# Access Compliance Report

## Public Rights-of-Way

| Intersection ID: 10025543               | Main Street: E_TRADE_ST | Cross Street: N/A                       | Location: E            |
| ADA ID: CFE20B965BC0                    | Ramp Type: Directional1 | Initial Pass/Fail: Fail                 | Overall Compliance: No |

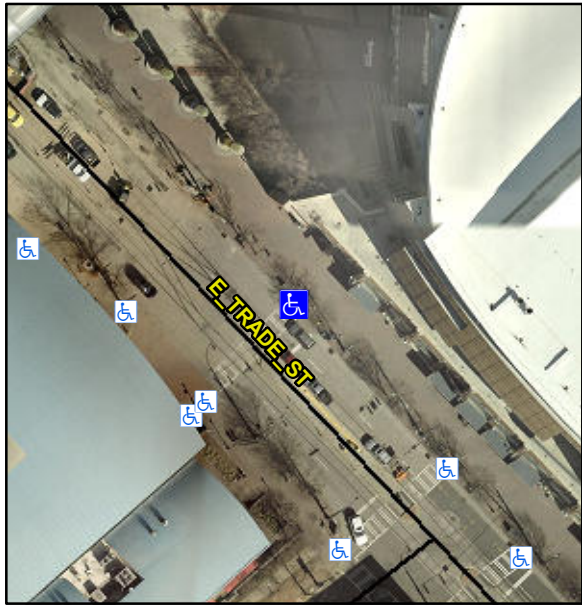
R304.2.2

| Compliance | Description           | Data  | Compliance | Description                 | Data |
|------------|-----------------------|-------|------------|-----------------------------|------|
| No         | Ramp Slope (%)        | 8.4   | N/A        | Grade Break XSlope (%)      | 0.0  |

Remove & Replace Entire Ramp.
